**Re: Expert Report of Greg Karras, Communities for a Better Environment (CBE), regarding the Phillips 66 Company Rail Spur Extension and Crude Unloading Project, Final Environmental Impact Report (FEIR), and Staff Report released 25 January 2016, SCH #2013071028, San Luis Obispo County File #DRC2012-00095**

**Expert Report of Greg Karras**

**Phillips 66 Company Rail Spur Extension and Crude Unloading Project**

**Final Environmental Impact Report (FEIR)** dated December 2015

**Santa Barbara County Energy Division Map, excerpted from:**  
[www.sbcountyplanning.org/energy/projects/PlainsPipeline.asp](http://www.sbcountyplanning.org/energy/projects/PlainsPipeline.asp).

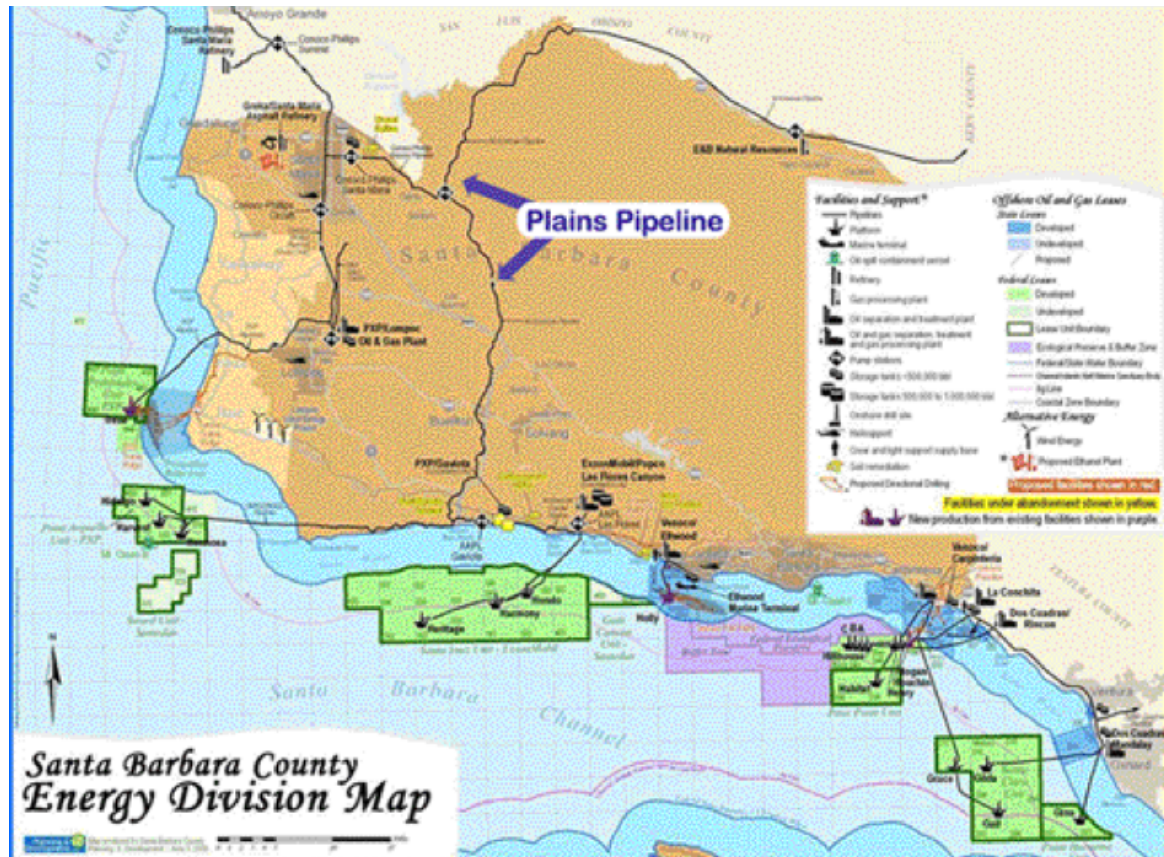
23. The further decline in local crude supply that is required before the FEIR’s oil trucking option can be implemented would idle additional local pipeline capacity. This would strongly incent efforts to repurpose the existing, idled infrastructure that might otherwise be a stranded asset. For example, some of the Plains All American Pipeline system could reverse flow to supply the SMF from the Bakersfield area via the Phillips 66 Line 300 from the Sisquoc Pump Station. A Santa Barbara County Energy Division map that illustrates the Plains All American and Line 300 pipeline routes, the SMF, and

other energy infrastructure in northern Santa Barbara and southern San Luis Obispo counties is excerpted below.

The Sisquoc Pump Station on the map is slightly below and to the left of the upper-most arrowhead indicating the Plains All American pipeline, below where the Plains line turns easterly toward Bakersfield. Line 300 runs toward the refinery from Sisquoc Station, to the Summit Pump Station. The 300,000 b/d capacity of the Plains line<sup>11</sup> and 84,000 b/d capacity of Line 300<sup>12</sup> would be ample for the SMF, and as pipelines tend to be costly to build and cheap to run, the opportunity to use an existing pipeline could be attractive.
